**GPU Nuclear Corporation**

Subject: Oyster Creek Nuclear Generating Station
Docket No. 50-219
Response to Request for Additional Information

**Response to NRC Request
for Additional Information**

Gap Size versus Integrated Gamma Exposure

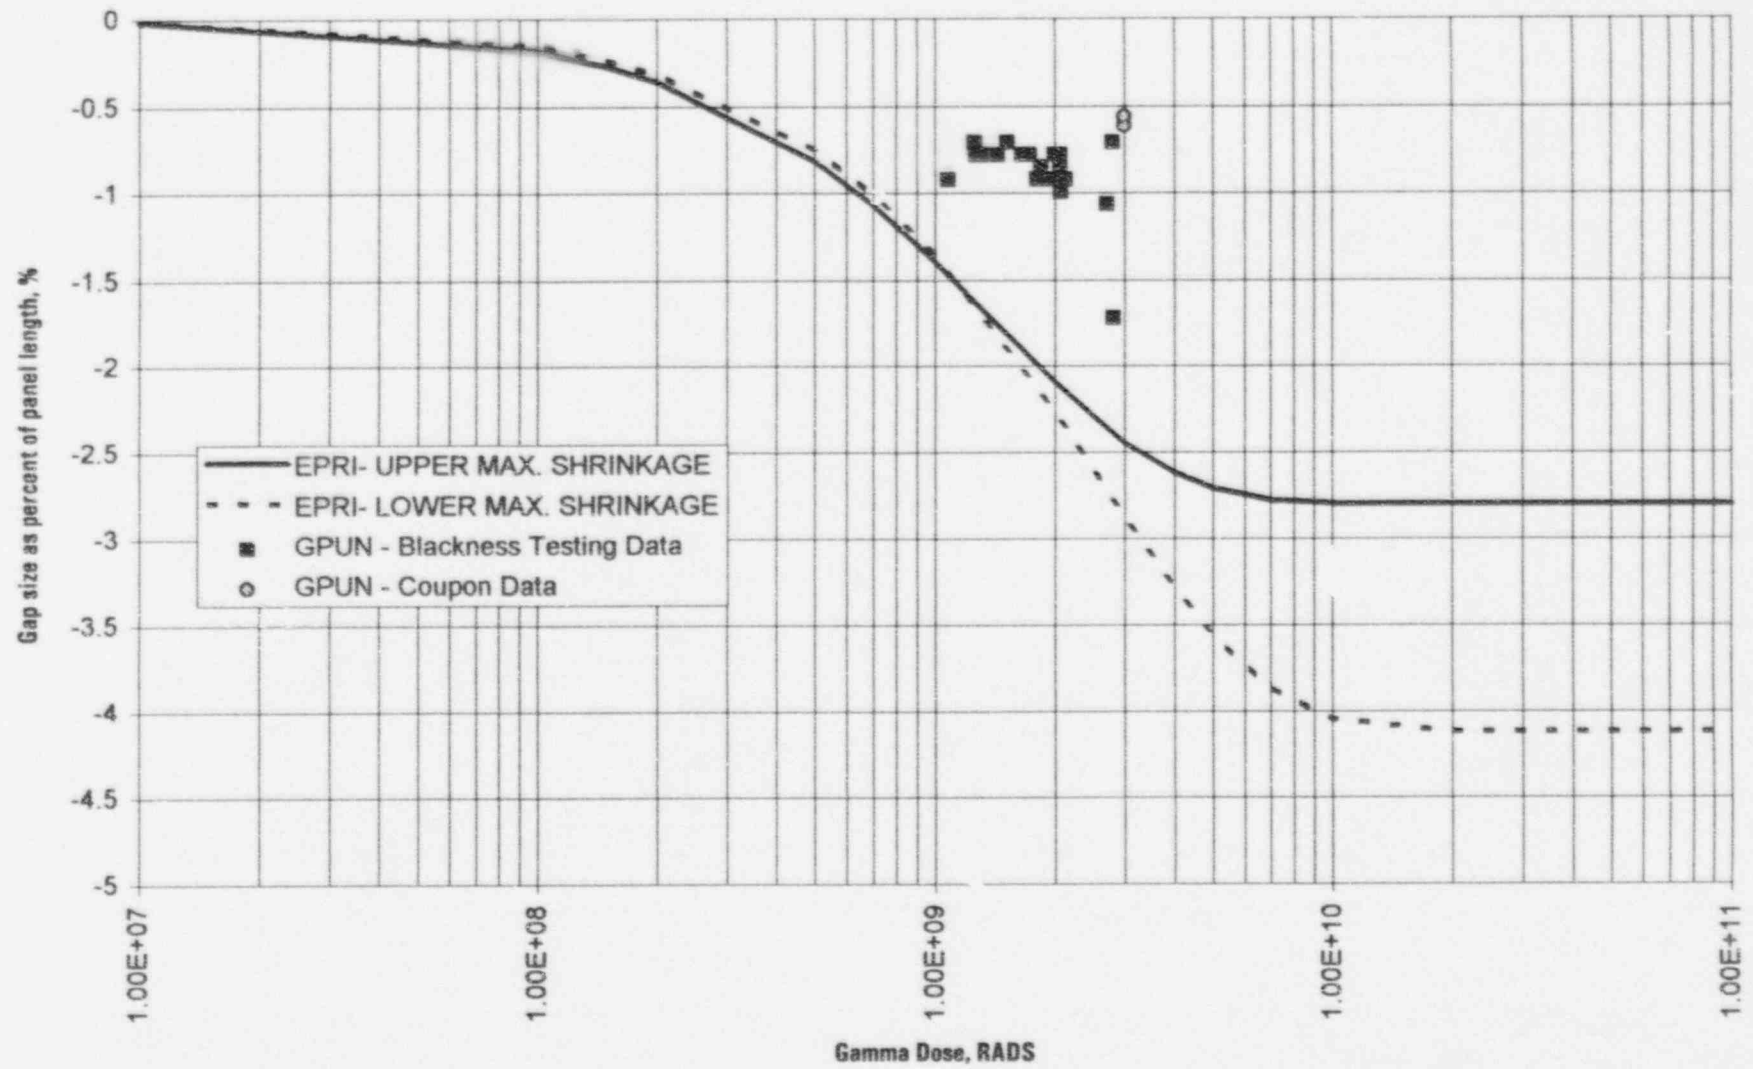
10. How was the maximum gap of 3.9 inches in Boraflex panels determined? What was the corresponding gamma exposure (rads)?

3.9 inches is the maximum expected gap size that would result from 2.8% Boraflex shrinkage based on EPRI studies (Reference 2) for the rack type

installed at Oyster Creek. The enclosed plot shows Oyster Creek's blackness testing results and coupon data as it compares to EPRI maximum expected shrinkage levels. The 2.8% is from the upper maximum shrinkage curve. This is the shrinkage associated with gap formation. Additional shrinkage will occur at the top and bottom ends of the Boraflex panels which has a very small effect on reactivity due to leakage effects. The largest total gap size found at Oyster Creek was 2.42 inches at an exposure of 3.0×10^9 rads (2 gaps of 1.07 and 1.35 inches). The shrinkage is expected to saturate at exposure levels greater than 1.0×10^{10} rads and gap growth is expected to be bounded by the 3.9 inch gap assumed in the coplanar gap analysis.
